# **Lime Down**

Solar Park

## **Change Application and Consultation Report (Change Application)**

**Document Reference: EXAM/9.40**

Title: Works Plans Comparison - Change 3.1

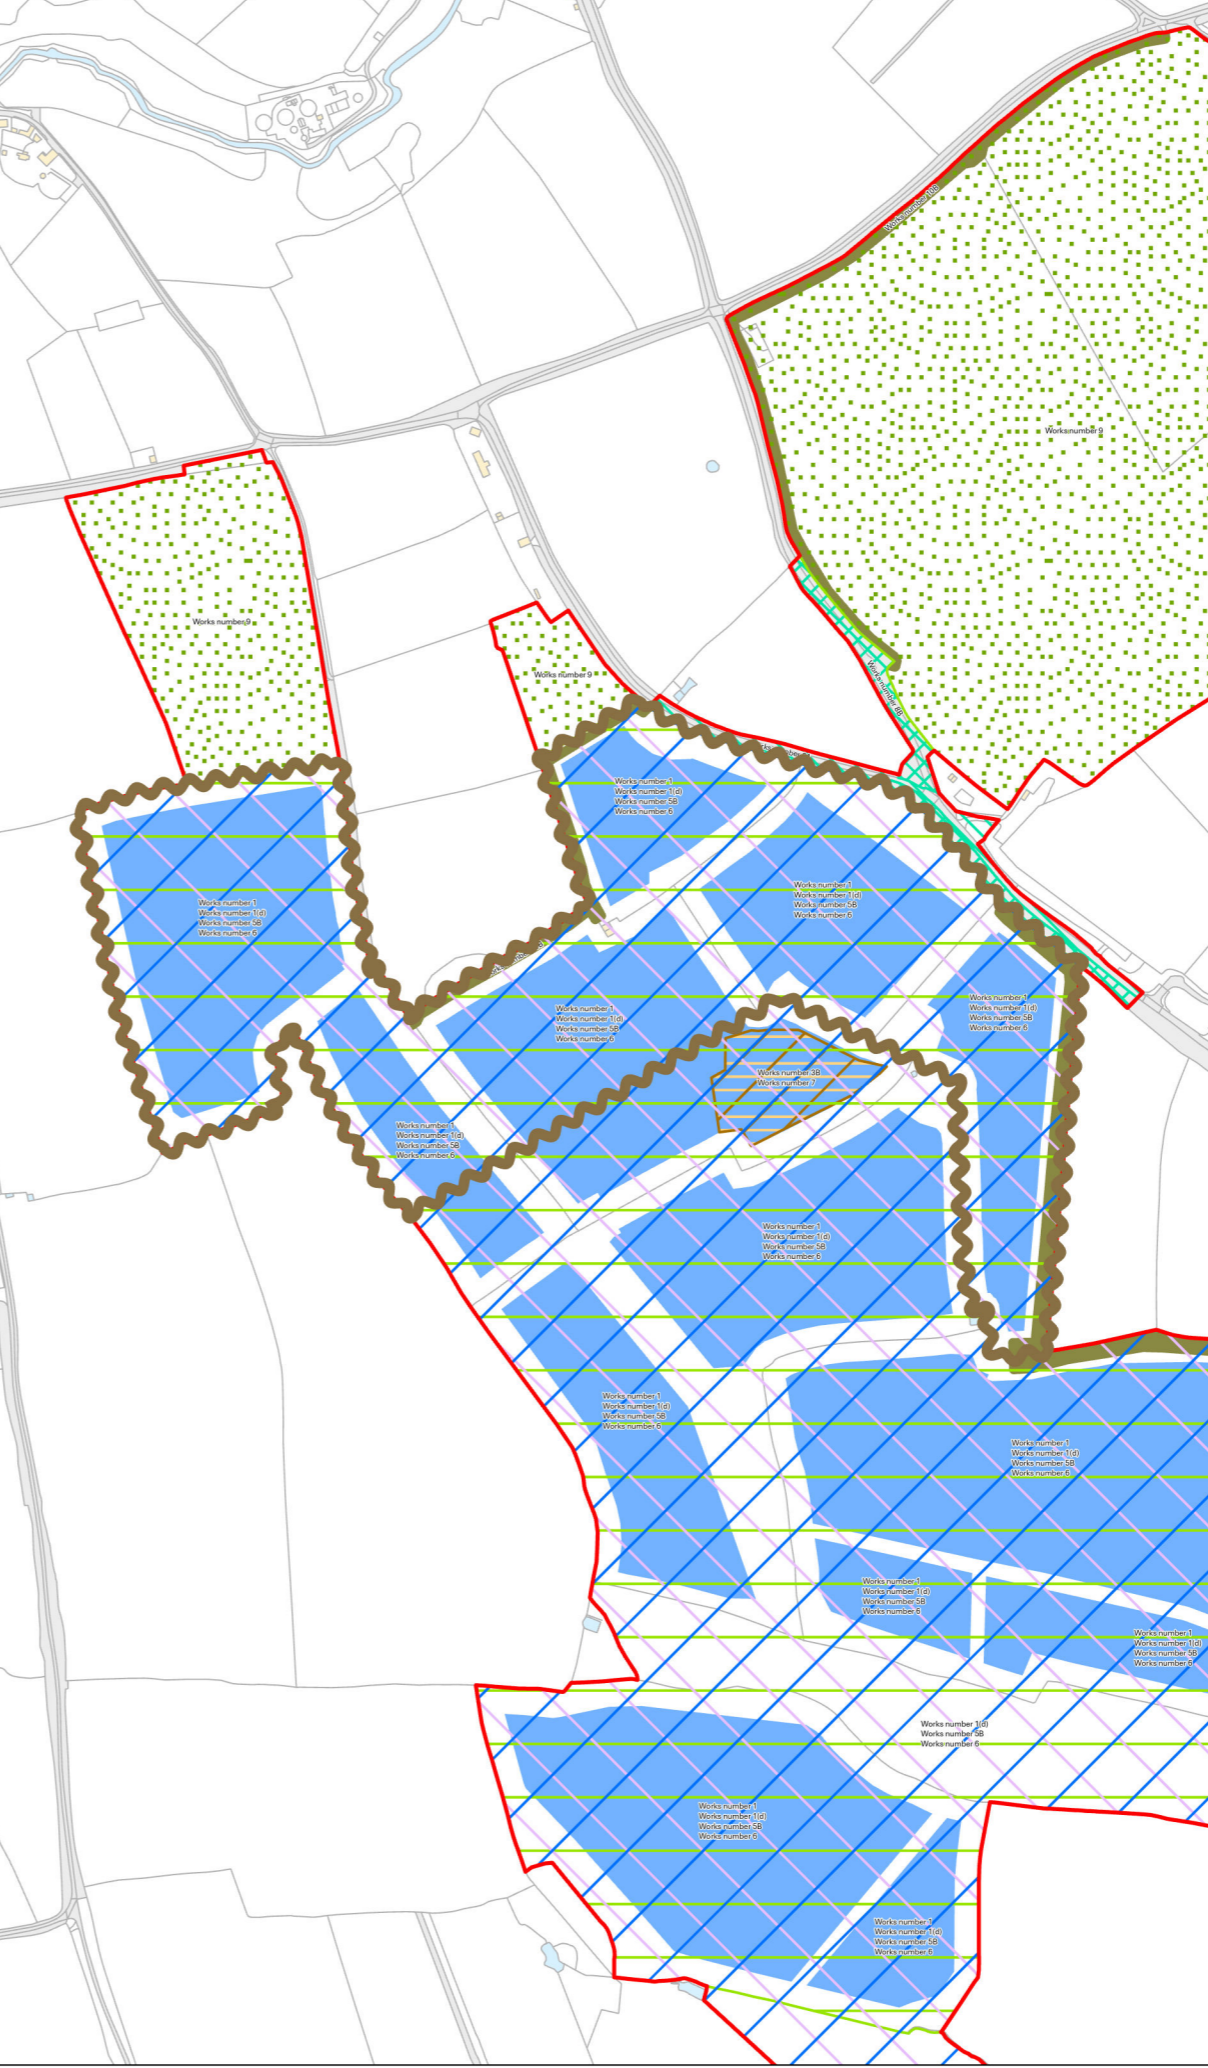
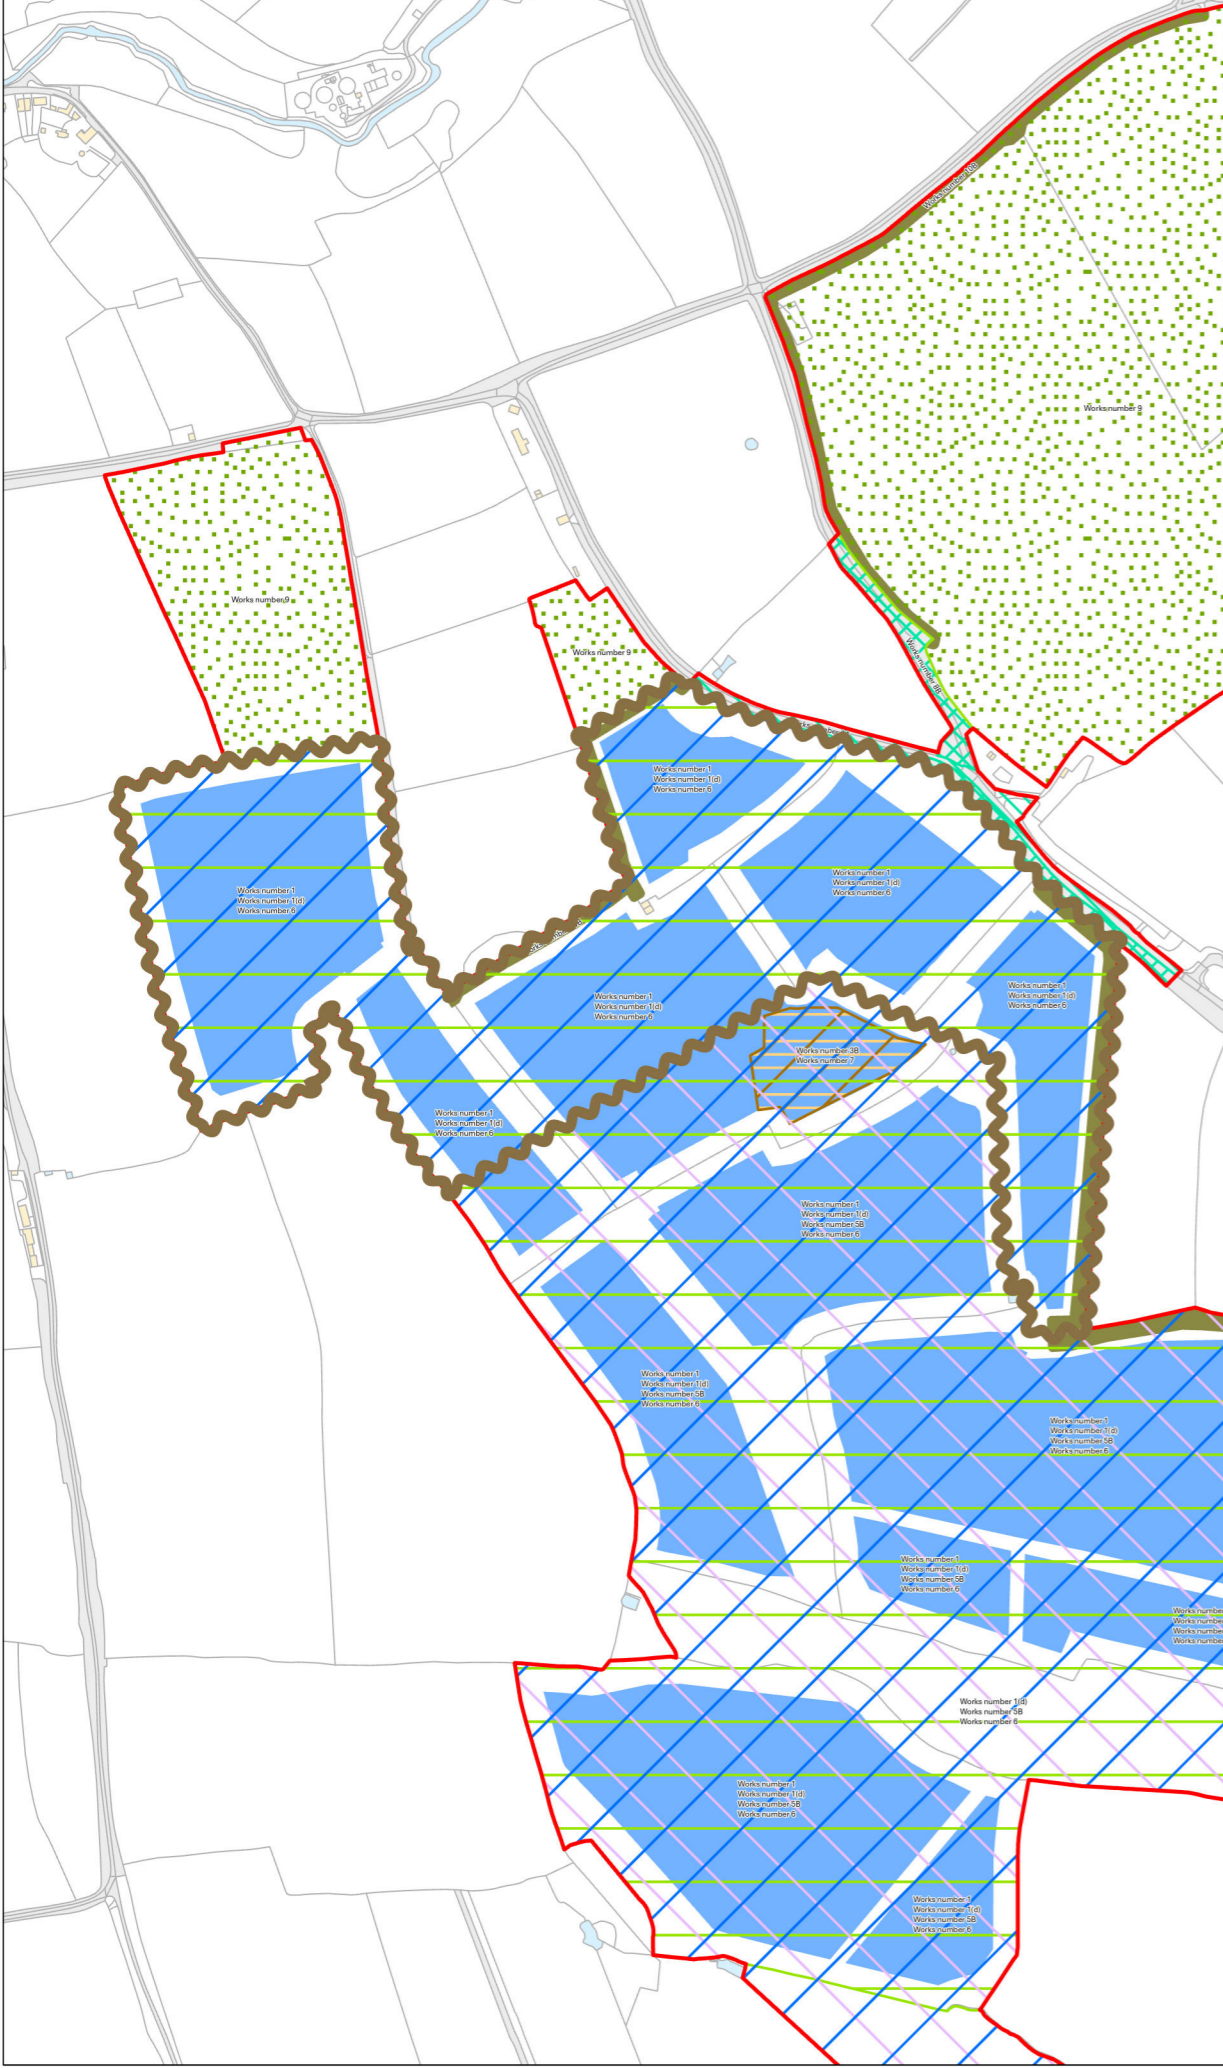
- 3.1.10 Change 3 comprises an update to some areas within Lime Down A, C and E to include Work Number 5B (electrical cables up to 132 kV (referred to as interconnecting cables in Table 3-1 in **ES Volume 1, Chapter 3: The Scheme [APP-055]**)) in addition to Work Number 1(d) (electrical and communications cabling (referred to as on-site cables in Table 3-1 in **ES Volume 1, Chapter 3: The Scheme [APP-055]**)).

- 3.1.11 The area comprising Work Number 1(d) allows for electrical and communications cabling within the Solar PV Sites, and some areas of Work Number 1(d) already include areas of Work Number 5B, however incorporating Work Number 5B across the entire area of Work Number 1(d) allows for more flexibility at the detailed design stage in the routing of the interconnecting cables between the Conversion Units, 33 kV Sub-distribution Switch Rooms, 132 kV Substations, 400 kV Substation and the Solar PV Sites. The plan provided shows the additional area in Lime Down A (Change 3.1), Lime Down C (Change 3.2) and Lime Down E (Change 3.3) where the Applicant is seeking to include Work Number 5B in addition to Work Number 1(d).

- 3.1.12 All cabling will be underground, and subject to the parameters stated in **Design Principles and Parameters [REP3-083]**. There is no change to the extent of the Order Limits associated with Work Number 5B being included in addition to Work Number 1(d). Change 3 allows for the interconnecting cables to be laid in the same location as on-site cables, where possible, including the design flexibility to place both interconnecting cables and on-site cables into a single trench.
- 3.1.13 The **Works Plan [EN010168/APP/2.3] [Change Application]** has been updated to reflect Change 3.

Title: Works Plans Comparison - Change 4

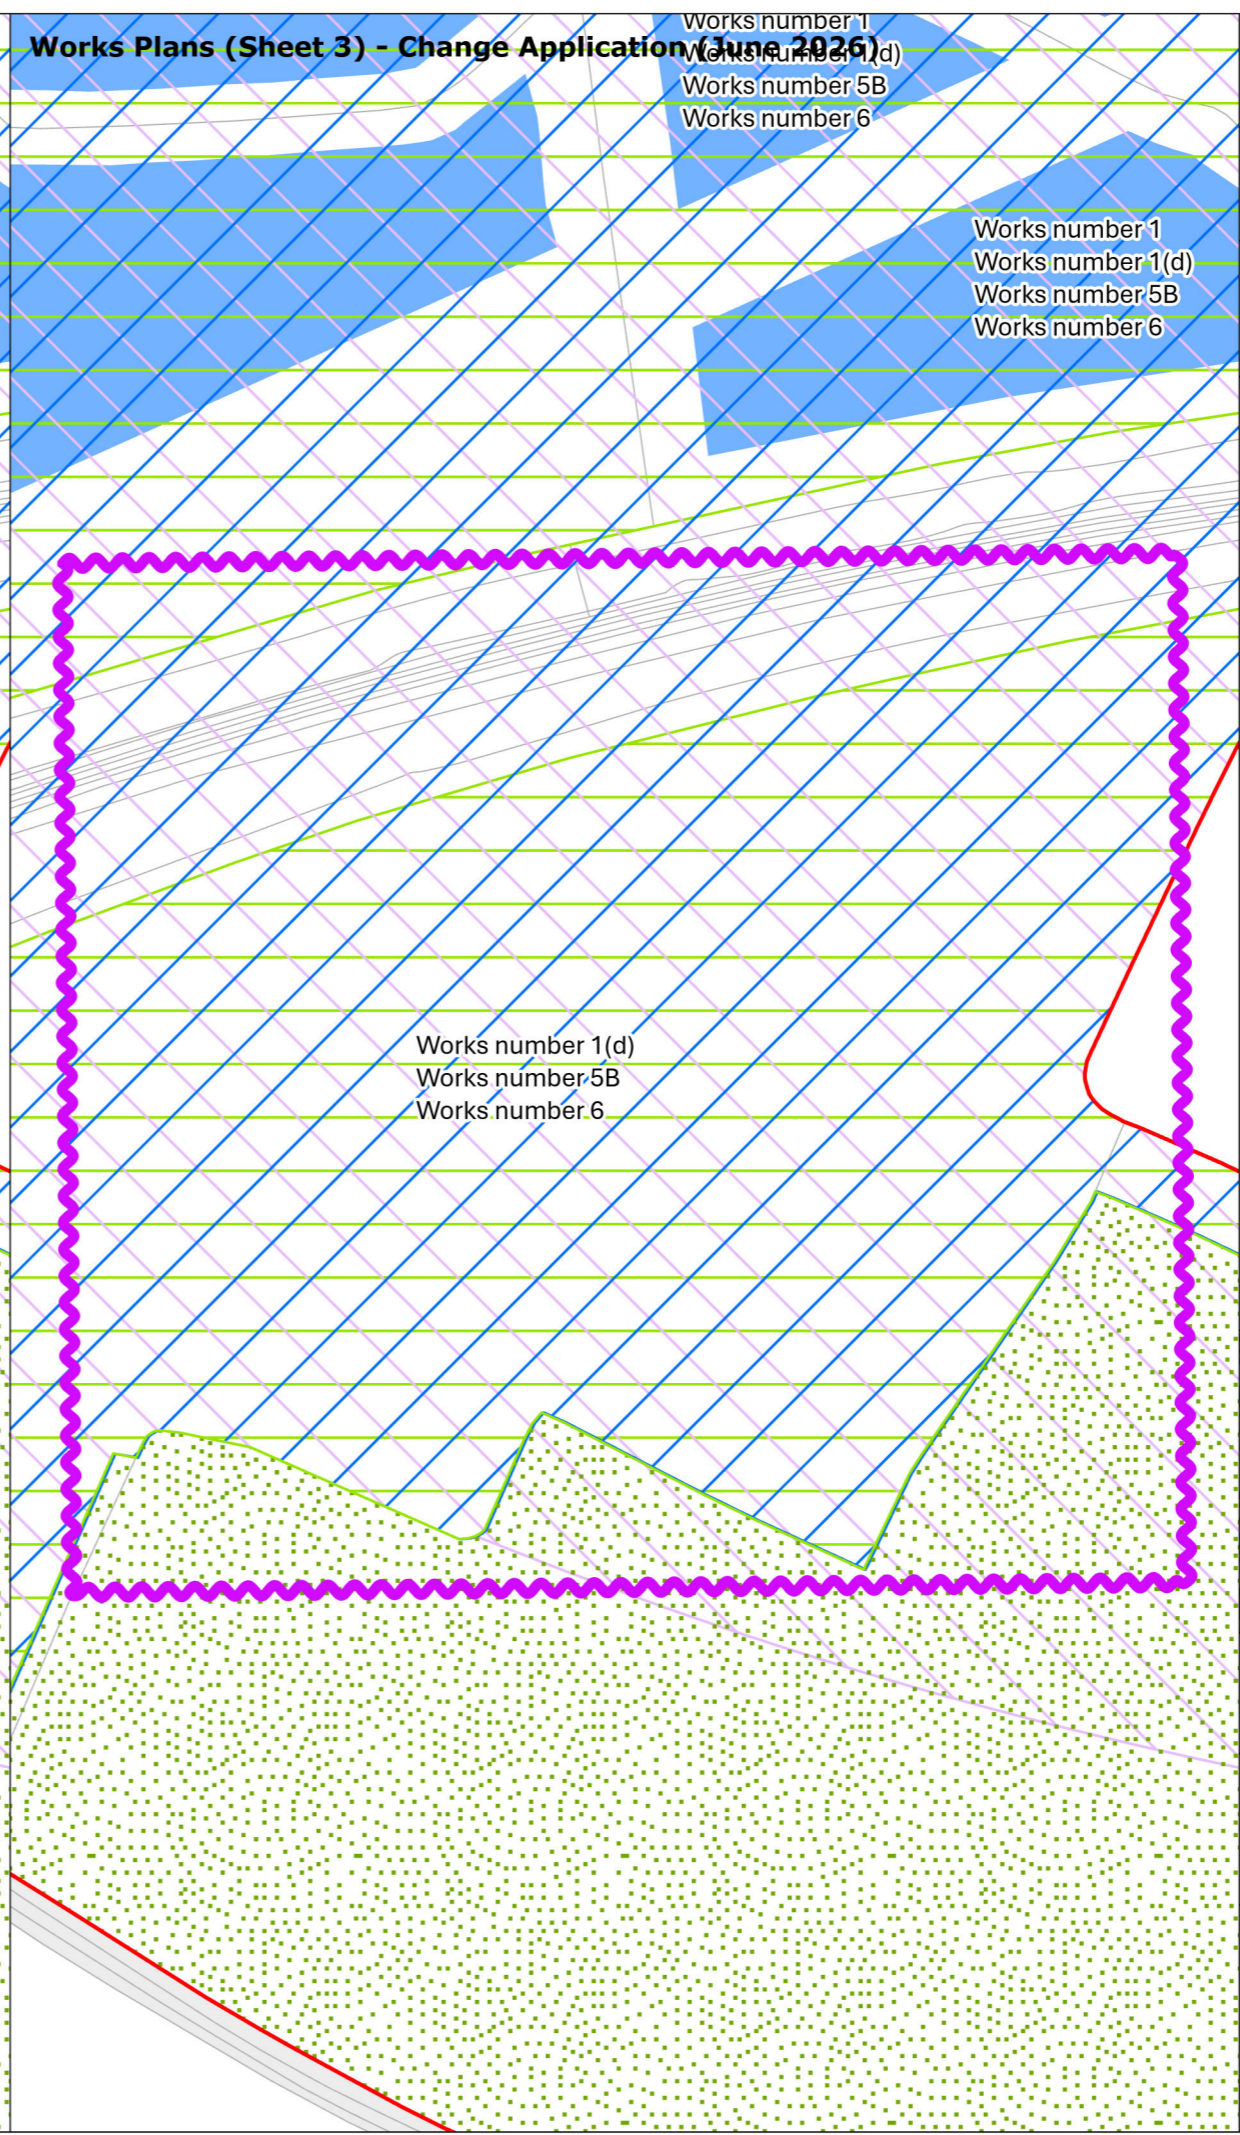
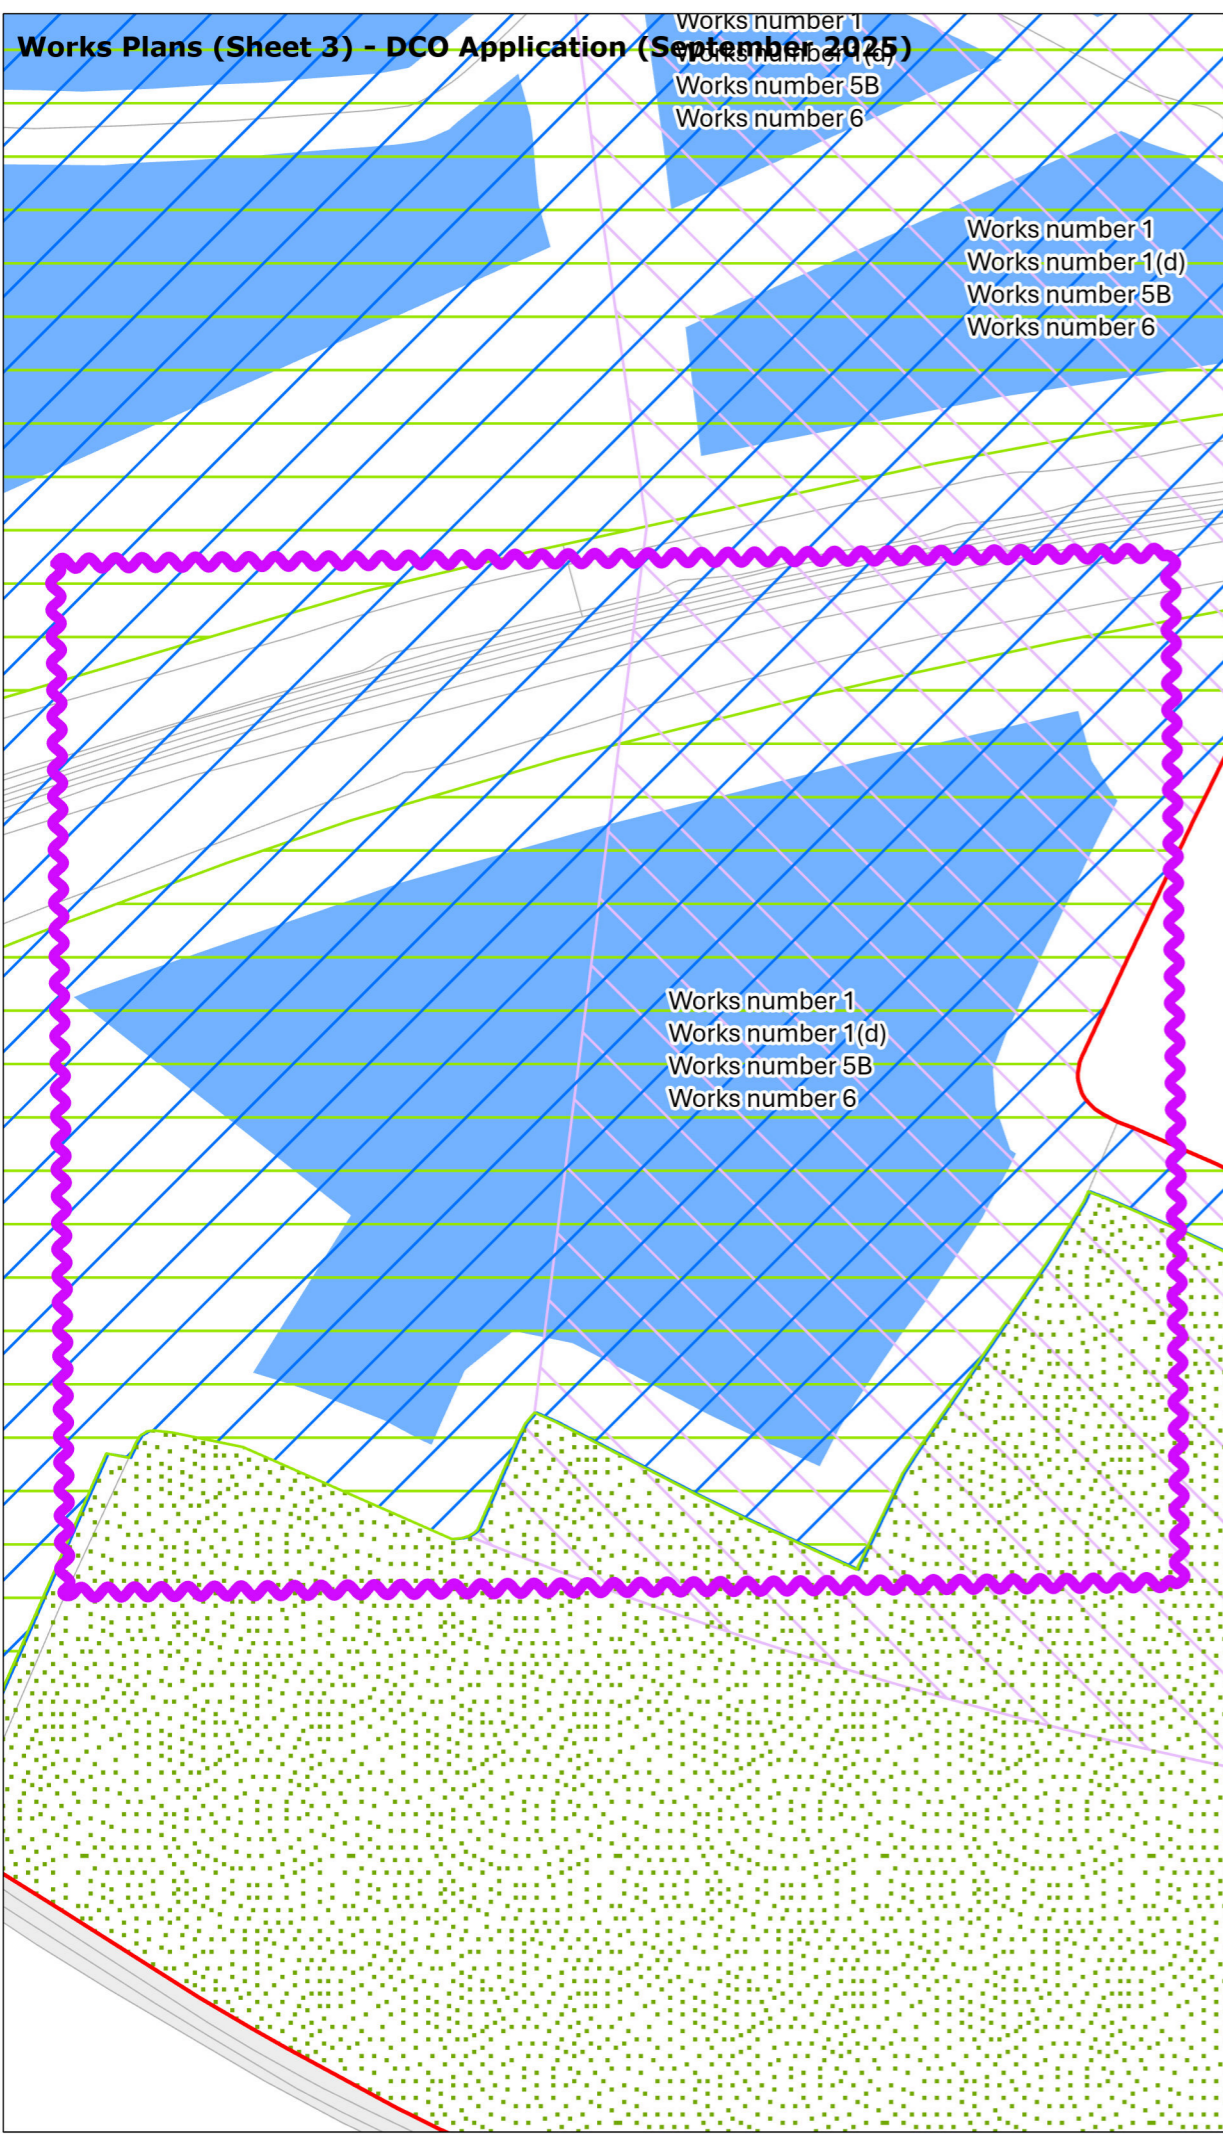
- 3.1.14 Change 4 comprises the removal of Solar PV Infrastructure from Field C9 to reflect ongoing engagement with the CNL Board related to the potential significant adverse visual effects for receptors located on Alderton Road. The removal of the Solar PV Infrastructure in this location results in a reduction in significant effects for Alderton Road.

- 3.1.2 In terms of grassland habitat types, as a result of Change 4 approximately 3.35 ha of grassland habitat within Field C9, previously proposed as 'modified grassland' beneath Solar PV Infrastructure, is now anticipated to comprise species-rich grassland with low-density scrub, corresponding to the habitat type 'other neutral grassland', as reflected in the **Biodiversity Net Gain Assessment Report [EN010168/APP/7.8] [Change Application]** and the **Biodiversity Net Gain Assessment Appendix Statutory Biodiversity Metric Calculation [EN010168/APP/7.9] [Change Application]**.

- 3.1.3 The removal of the Solar PV Infrastructure in this location results in a reduction in significant effects for Alderton Road.
- 3.1.4 The **Works Plan [EN010168/APP/2.3] [Change Application]** and Parts 1-4 of the **ES Volume 2, Figure 3-4 Landscape and Ecology Mitigation Plan [EN010168/APP/6.2] [Change Application]** have been updated to reflect Change 4.
